June 11, 2009

SUBJECT: RESPONSE TO A NON-CONCURRENCE ON DRAFT REGULATORY
GUIDE DG-1199, "ALTERNATIVE RADIOLOGICAL SOURCE TERMS
FOR EVALUATING DESIGN BASIS ACCIDENTS AT NUCLEAR
POWER REACTORS"

Background on DG-1199

Figure 1 Idealized regulatory model of airborne fission products (left) compared to realistic prediction of airborne radioactivity (right) during release phase of a DBA with core damage. Note, in actuality the source of airborne activity emanates from vessel core (right)

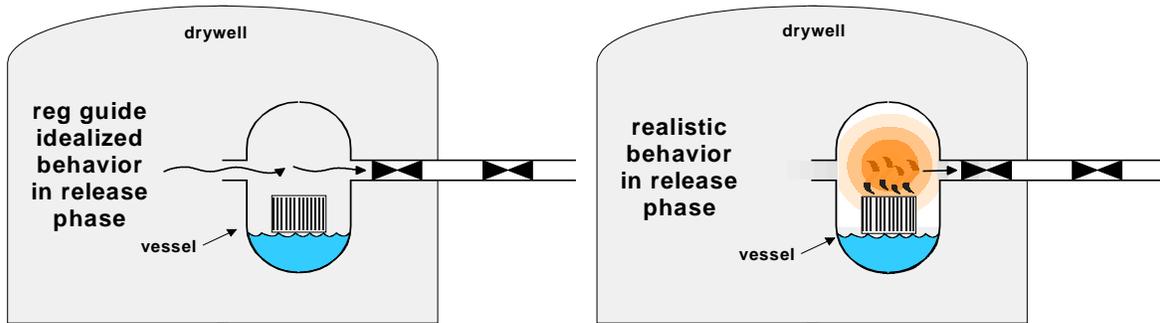
RG 1.183, Revision 0, like its Regulatory Guide 1.3 and 1.4 predecessors, assumed that the concentration of radioactivity used as the source of the MSIV leakage is approximated by the concentration of radioactivity in the containment following a postulated core melt. The radioactivity from the core melt is assumed to mix instantaneously and homogeneously throughout the free air volume of the containment building and reactor coolant system piping. This idealized view presumes that the radioactivity is released from the fuel, transported out of the vessel, and instantaneously and homogeneously distributed within the drywell volume. This equilibrated drywell atmosphere is assumed to be the source of the flow through the leaking MSIVs. In reality, the radioactivity in the vessel steam dome is not instantaneously equilibrated with the drywell or containment volume (See Figure 1).

The SNL report demonstrated that radioactivity transport is very different from the assumptions currently in RG 1.183. The current RG 1.183 methodology underestimates the MSIV leakage source term during the first two hours of the DBA. RG 1.183 assumes that the vessel and containment atmosphere are in equilibrium before reflood and that the containment atmosphere can be used as the source of the MSIV leakage. The technical validity of this assumption was explicitly evaluated in the SNL research. The SNL report documented findings from MELCOR code runs which showed that the concentration of radioactivity in the steam dome may be substantially higher than in containment until reflood occurs. After reflood, the vessel activity is swept into the containment and over time the vessel and containment atmosphere equilibrate. Therefore, consistent with the SNL research, DG-1199 proposes to use the concentration of radioactivity in the steam dome before reflood, and thereafter use the concentration of radioactivity in the containment.
